UNITED STATES PATENT AND TRADEMARK OFFICE

APPLICATION NO.	FILING DATE	FIRST NAMED INVENTOR	ATTORNEY DOCKET NO.	CONFIRMATION NO.
10/553,061	04/26/2006	Thomas Roiser	4301-1147	4268

Office Action Summary

DETAILED ACTION***Drawings***

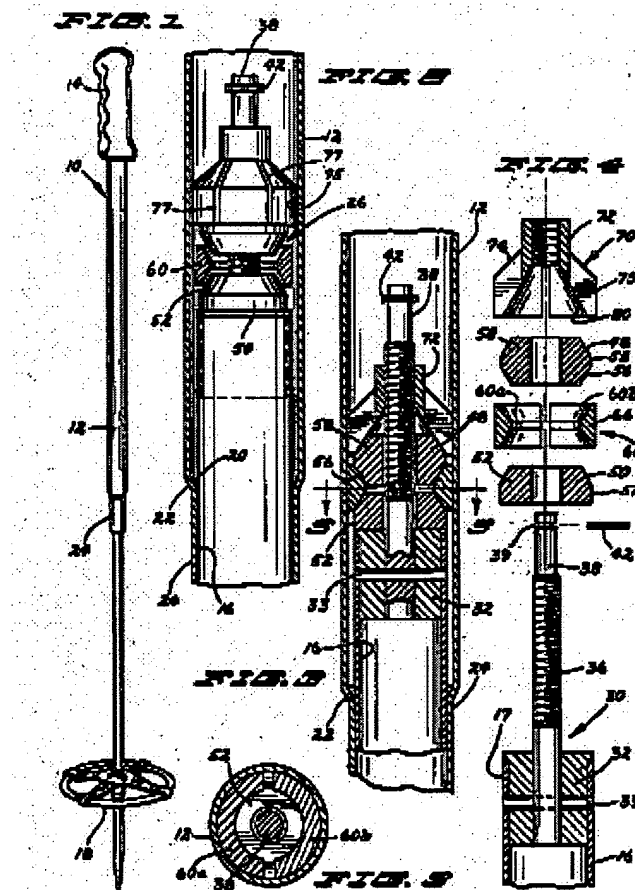
With respect to claim 13, Hinners discloses a clamping device (**Figs. 1-4, see below**) for telescoping tubes (**12, 14**), with a radially expandable clamping part (**60**) which is hollow cylinder has a continuous lengthwise slot, conical expansion bodies (**50, 70**) being assigned to

the two ends characterized in that the expansion bodies (50, 70) can be moved relative to the clamping part (60), and are screwed onto threaded sections (**constituted by the upper and lower sections of threaded 36**), of the threaded rod (30) with opposing threads, and that a threaded part (30) which has a threaded rod (30) is attached to the inner tube of the telescoping tubes (12, 14).

With respect to claims 15-17, Hinners discloses (Fig. 5, see above) that the hollow cylinder (60) which forms the clamping part has recesses (**constituted by space between parts 60a and 60b**) which proceed from its two ends; wherein the two recesses are diametrically opposite one another on each end of the hollow cylinder (60).

With respect to claim 18, Hinners discloses (Fig. 2, above) that the expansion bodies (50, 70) with their ends of smaller diameter engage the clamping part (60).

**Fig-1**

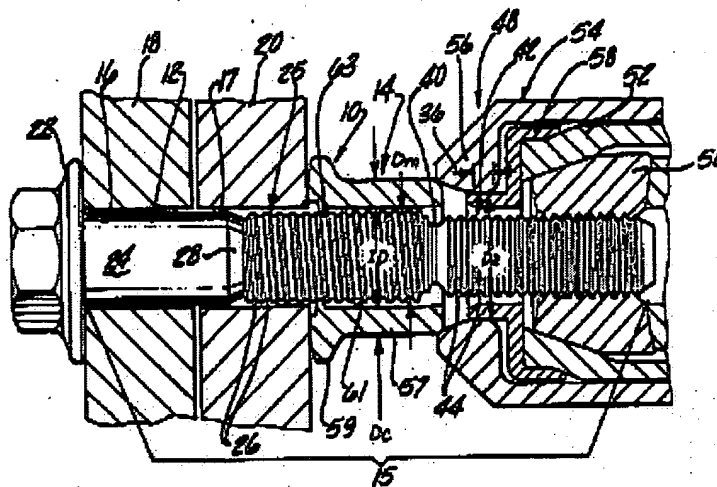
With respect to claim 19, Hinnars discloses (**Fig. 2, above**) that the expansion bodies (**50, 70**) their ends with the greater diameter are made to increase friction relative to the material of the outer tube (**12**).

With respect to claim 14, Hinnars discloses the claimed invention except that the threaded section of the screw that is adjacent to the inner tube has a greater diameter than the threaded section which is remote from the inner tube. Dixon teaches a clamping device (**10, Figs. 1-2, see below**) including a screw (**12**) having a first threaded portion (**25**), which has greater diameter, than a second threaded portion (**24**). It would have been obvious to one of ordinary skill in the art at the time of invention was made to modify the screw of Hinnars to have a first threaded section with a greater diameter than a second threaded section as taught by Dixon in order to clamp two members together at a preselected preload by the axial force initially applied between the screw and collar.
